RELEASED FOR CONSTRUCTION
As Noted on Plan Review

Street & Storm Cover Sheet

Oldham Village

REV.	DATE	DESCRIPTION
1	12/10/2024	REV. 12/10/2024
2	1/2/2025	REV. 1/2/2025
3	2/6/2025	REV. 2/6/2025
4	3/5/2025	REV. 3/5/2025
5	3/24/2025	REV. 3/24/2025
6	4/15/2025	REV. 4/15/2025
7	10/16/2025	REV. 10/16/2025

Grading Plan South
Construction Plans for:
Ovation
Lee's Summit, Jackson County, Missouri

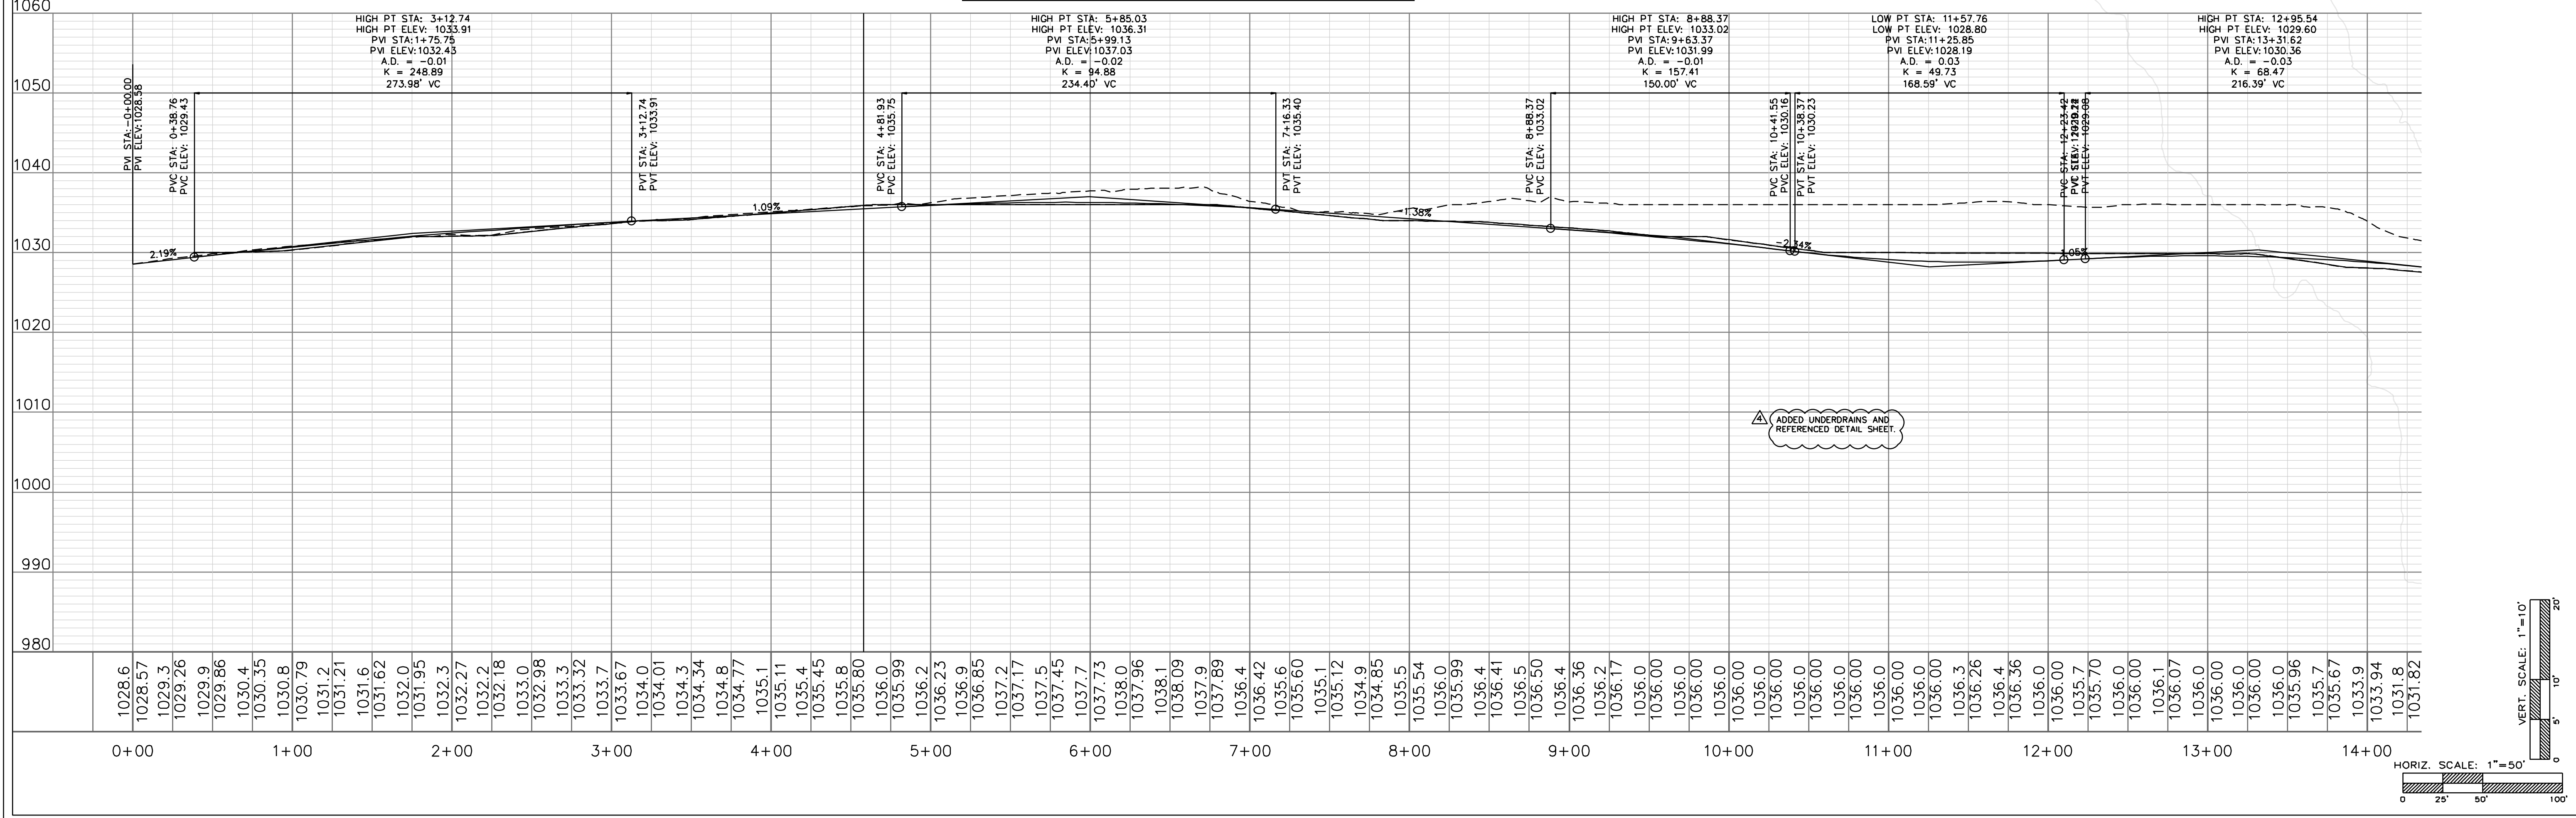
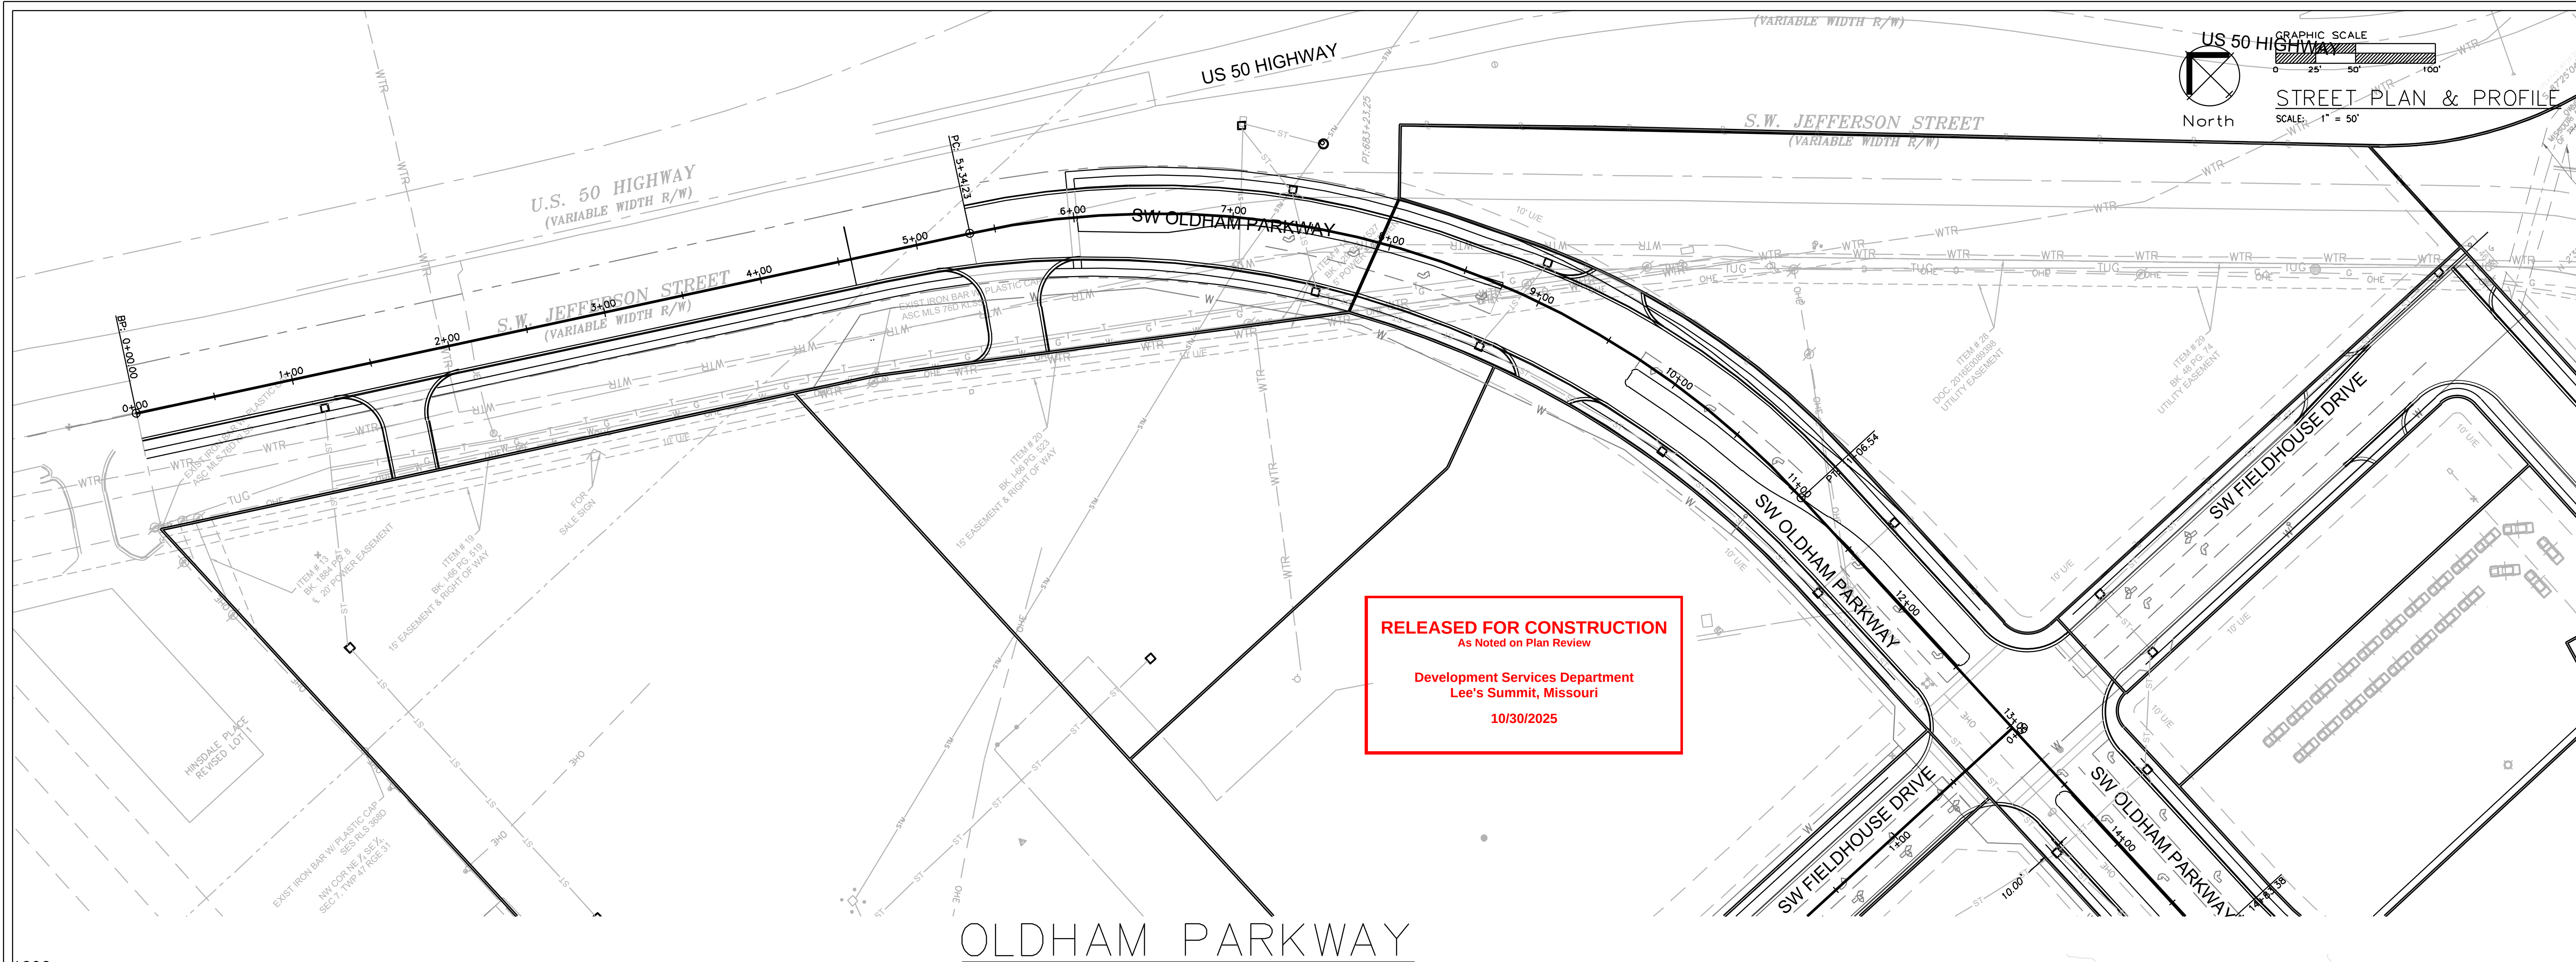
Revised plan to show the extent of grading to the west of the plot boundary
